PRODUCT TECHNICAL BULLETIN #96

**verSI twinax cable conductor and shield
termination change**

Product Lines: verSI™

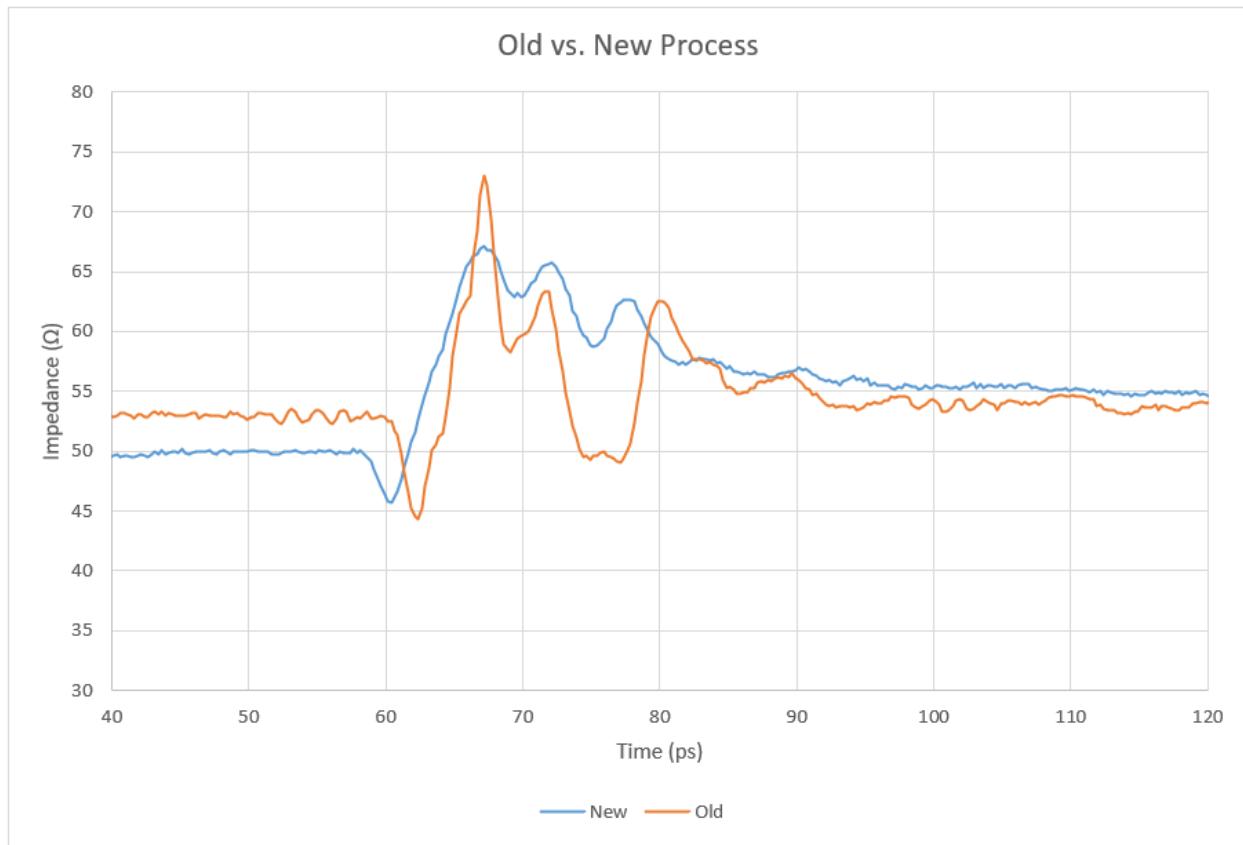
TDR measurements with a rise time of 7 ps show the new construction has an impedance that is smoother and more consistent than before, including a smaller impedance drop at the soldered termination and a smaller initial impedance spike at the verSI connection.
